Access Compliance Report

Public Rights-of-Way

(Curb Ramps)

Intersection ID: 28429	Main Street: CHASTAIN_PARC_DR	Cross Street: LADY_ANN_CT	Location: SE
ADA ID: 75E255B02820	Ramp Type: Perp	Initial Pass/Fail: Fail	Overall Compliance: No
Severity Score: 8.75			
Codes/Mitigation Info/Possible Solution		Field Measurements/Component Compliance

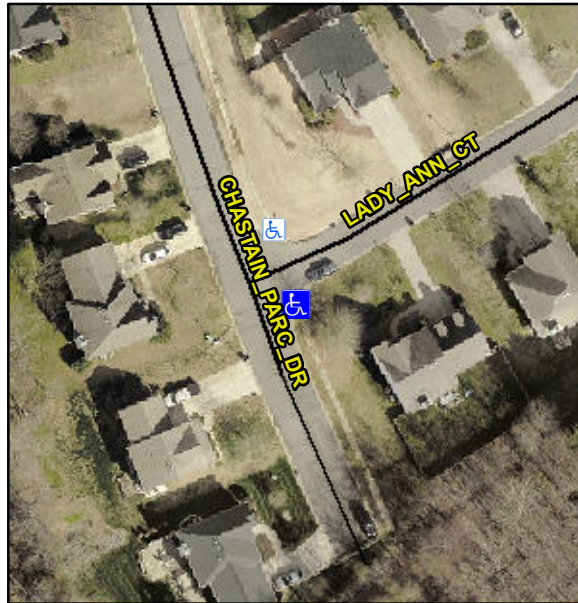
Not Found, R304.5.1

Compliance	Description	Data	Compliance	Description	Data
N/A	Ramp Length (in)	44.5	Yes	Ramp Slope (%)	6.2
No	Ramp Width (in)	38.5	Yes	Ramp XSlope (%)	0.2
N/A	Flare Type LT	N/A	N/A	Flare Type RT	N/A
N/A	Flare Slope LT (%)	N/A	N/A	Flare Slope RT (%)	N/A
N/A	Flare Traversable LT?	N/A	N/A	Flare Traversable RT?	N/A
N/A	Landing Length (in)	N/A	N/A	DWS Provided?	N/A
N/A	Landing Width (in)	N/A	N/A	DWS Contrast?	N/A
N/A	Landing Slope (%)	N/A	N/A	DWS Length (in)	N/A
N/A	Landing X Slope (%)	N/A	N/A	DWS Full Width?	N/A
N/A	Landing Curb? (Y/N)	N/A	N/A	DWS Offset (in)	N/A
N/A	Shared Landing?	N/A			
N/A	Gutter Ponding?	N/A	N/A	Gutter Slope (%)	N/A
N/A	Gutter Lip Ht (in)	N/A	N/A	Gutter X Slope (%)	N/A
N/A	Painted X Walk1?	No	N/A	Painted X Walk2?	N/A
	X Walk 1 Direction	To NE		X Walk 2 Direction	N/A
N/A	X Walk 1 Width (in)	N/A	N/A	X Walk 2 Width (in)	N/A
	X Walk 1 Slope (%)	5.7		X Walk 2 Slope (%)	N/A
	X Walk 1 X Slope (%)	1.0		X Walk 2 X Slope (%)	N/A

Remove & Replace Entire Ramp.
